D/DRC Case

3101 Lindsay Street

DESIGN/DEVELOPMENT REVIEW COMMISSION
DESIGN REVIEW DISTRICT
HISTORIC AGENDA
EVALUATION SHEET
Case # 8

NATURE OF REQUEST: Request Certificate of Design Approval for additions

Right: red line is rough outline of proposed dormer on front roof plane

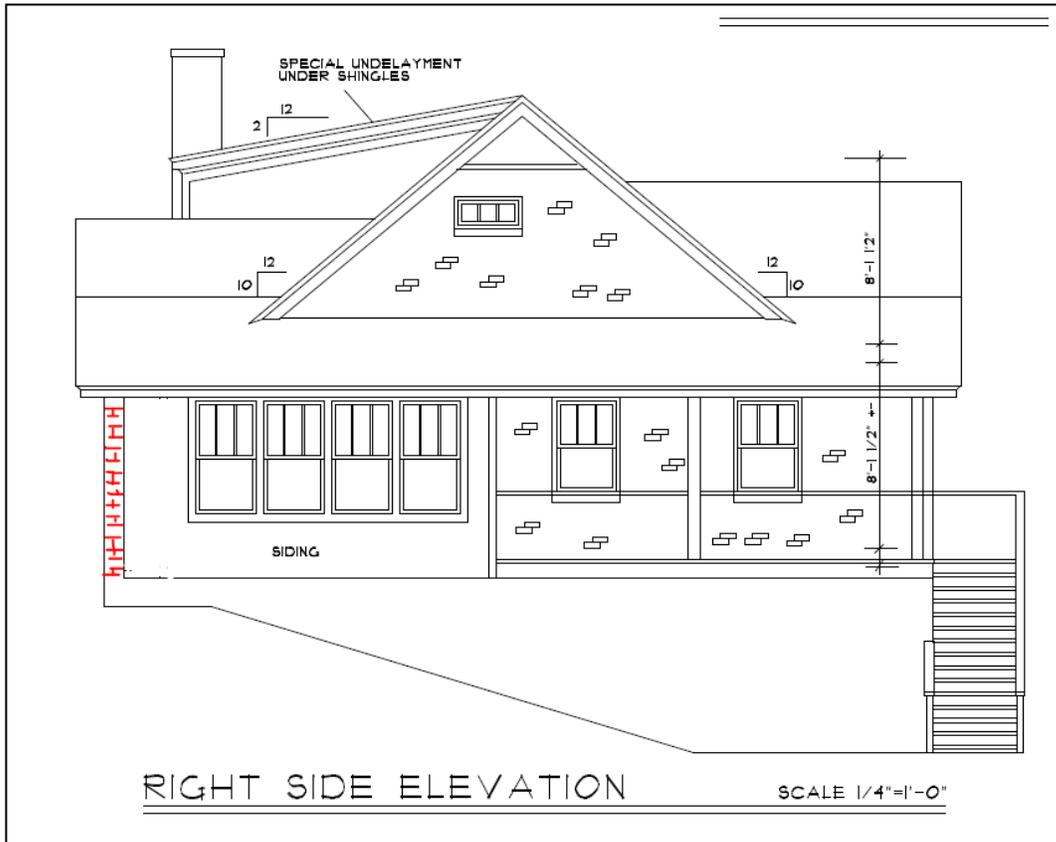
The dormer addition has been reduced in size from a proposed large front gable to a shed roof. However, it is still much larger than dormers found in the neighborhood as it extends all the way from the roof ridge to the front wall plane. Most dormers are much smaller and their footprints do not typically extend this distance. This seems to be necessary when looking at the proposed new floorplan of the second floor, to allow headroom at the top landing for the staircase. Therefore, the interior floorplan may need to be rearranged to minimize this dormer or to generate a dormer on the rear of the house.

Altered proposal putting side addition back flush with façade (per applicant’s preference) and adding brick corner “column” (Staff alteration). Unaltered version is attached. Proposed dormer is unaltered.

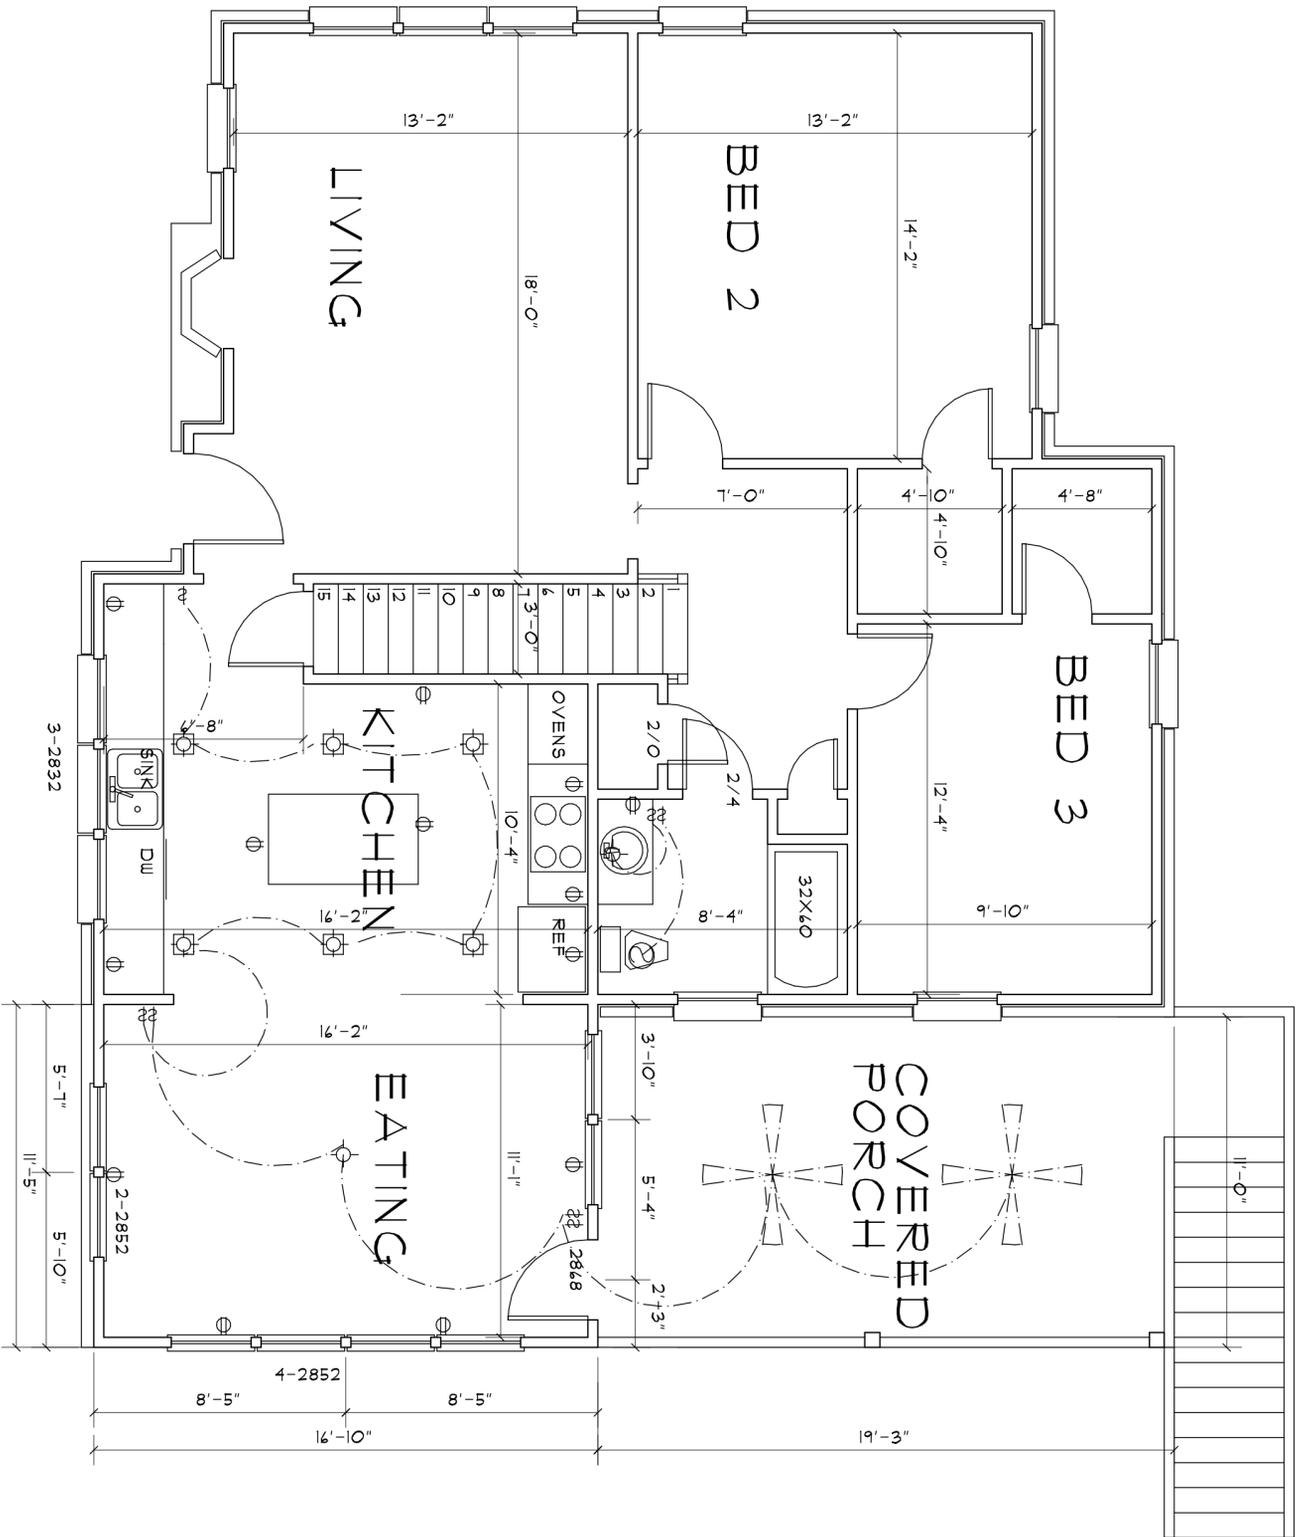
Altered proposal removing heavy molding in side addition gable and replacing with siding (Staff alteration). Unaltered version is attached.

- *that the dormer addition be reduced in overall size in order to be subordinate and to mimic typical dormer patterns found in the district
- *that if the dormer cannot be reduced to a design compatible with the guidelines, then staff can work with the applicant on a rear dormer option
- *that the side addition have the roof pitch raised to at least 4/12 and altered to a hip roof
- *that the side addition gain brick veneer “column” on the front right corner that is two bricks wide
- *all details deferred to staff

FRONT ELEVATION

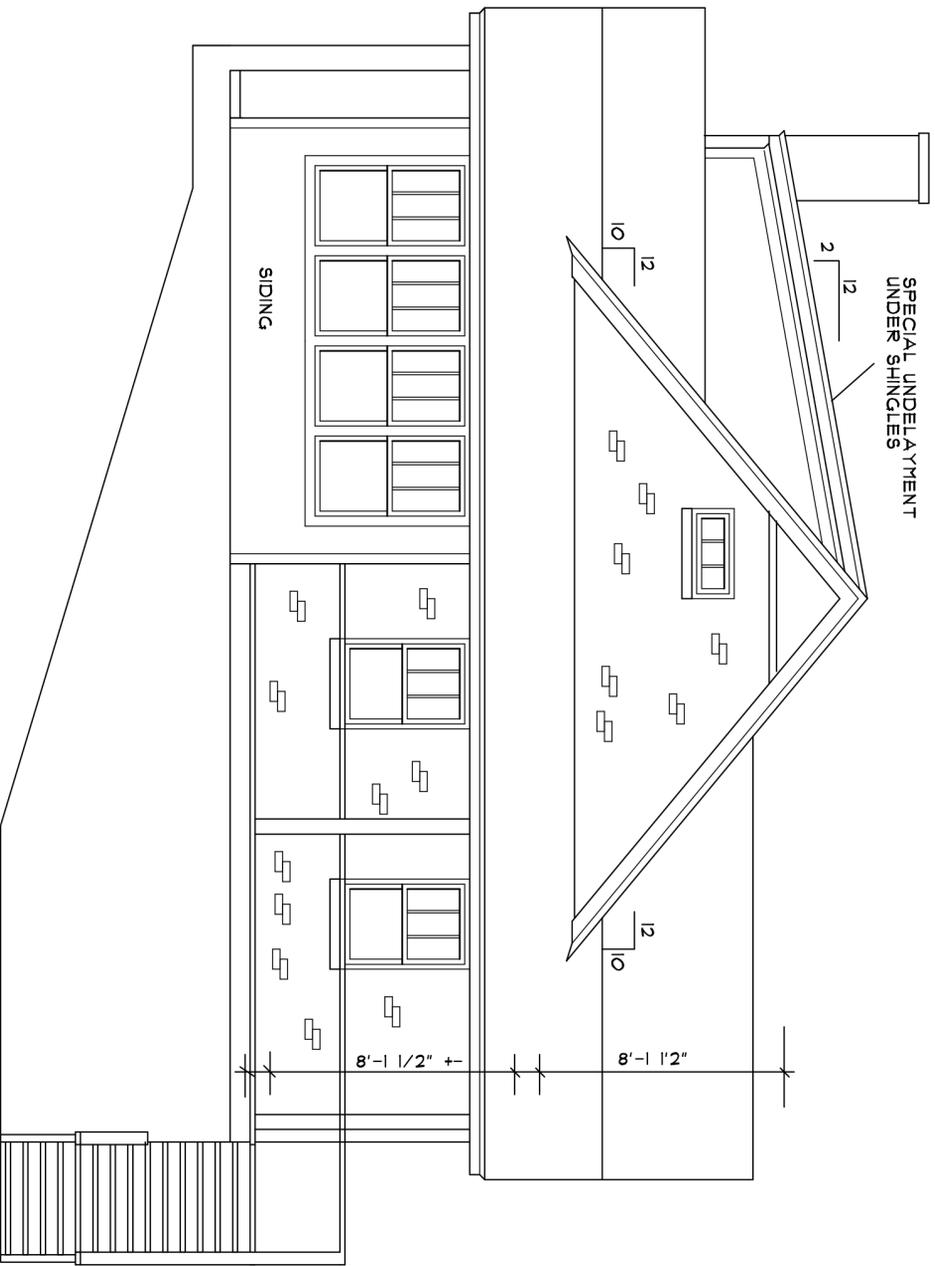
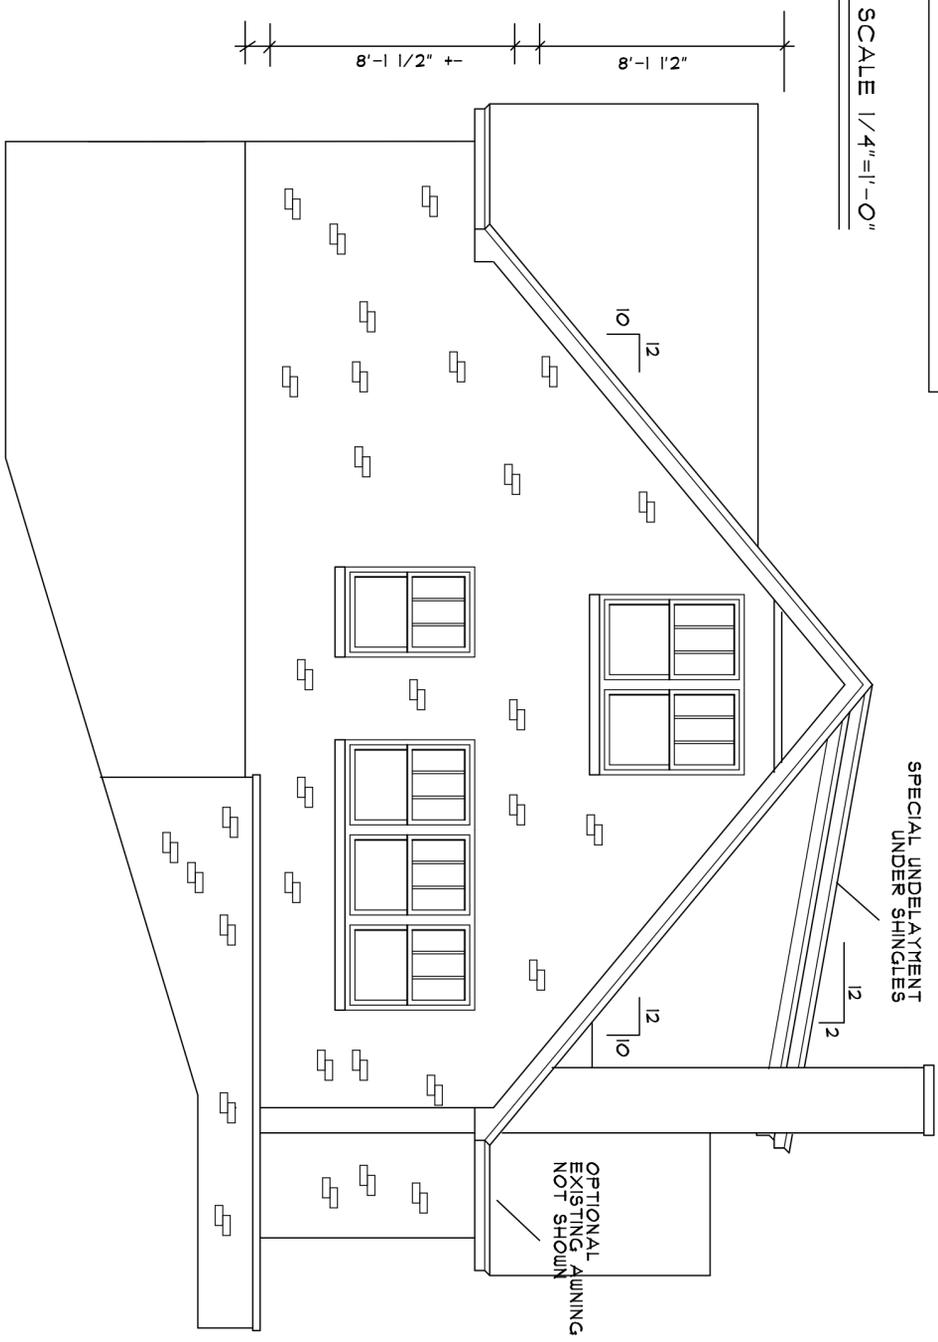
The dormer addition is extended to the front plane of the façade, where a small gable above the door currently exists. In earlier drawings this gable above the door was removed but in the latest drawing this gable design is remaining intact. The retention of this important architectural feature moves closer to meeting this guideline, but due to the dormer's extension to the front wall plane this small gable will no longer read as a gable. It will be encased in the wall surrounding it and no longer read as an original architectural feature meant to highlight the main entrance. Therefore, the dormer as proposed does not meet this guideline as it detracts from and obstructs an important architectural feature. If the dormer addition can be reduced in size to leave this feature intact then it would be closer to meeting this guideline, but it appears the interior floorplan as currently proposed would not allow a reduction in size for the dormer.

The side addition detracts from the understanding of the original width and corner of the façade because it is placed flush with the façade. Typically side additions are encouraged to be set back from the façade so that the original building can be understood. However, this building has an existing foundation line that extends past the façade and underneath the siting of the new addition, which is currently a deck. This front wall of the foundation is actually a basement and is somewhat of a retention wall. Moving the wall of the addition back would expose the basement foundation and leave a platform in front of the wall.

The original design for the dormer and side addition featured very heavy molding and a pedimented half gable in the front of the side addition. This type of detailing is not found on the original structure. The applicant has removed the additional molding and pedimented half gable in order to simplify this detail and better meet the guideline; the plans submitted do not reflect this change so staff has generated an altered version at the end of the evaluation for conceptual purposes only. This would allow the siding to go up and over the projecting front gable, which is also not a detail that is compatible. An alternative to this issue would be a hip roof.

The roof of the side addition meets two rooflines: the main side gable and the projecting front gable. This presents some problems with the rooflines meeting together in a way consistent with the existing architecture. The proposed pitch is also quite low, at 3/12. The pitches on the original house are about 10/12, according to information supplied by the applicant. The pitch of the shed roof dormer is understandably low at 2/12, in order to get the head height needed at the top of the stairs, but the side addition would need to gain some pitch in order to be more compatible with the original house, especially given the two front gables facing the street which so clearly delineate the pitch. The pitch might be more obscured if the applicant was to alter the roof design from a shed roof to a hip roof; a sketch of this possibility is included in the evaluation.

The dormer addition has been reduced from a large gable addition but its required size, which extends it the full length of the front roof plane from the ridge to the front wall, makes it a more dominant feature rather than subordinate. The size and scale of the front dormer addition should be reduced to meet this guideline, but if that is not possible due to the need for headroom at the top of the stairs then the stairs might need to be re-oriented in the opposite direction. This would require the moving of some of the proposed features in the second floor so that the stairs do not open up into the bathroom.
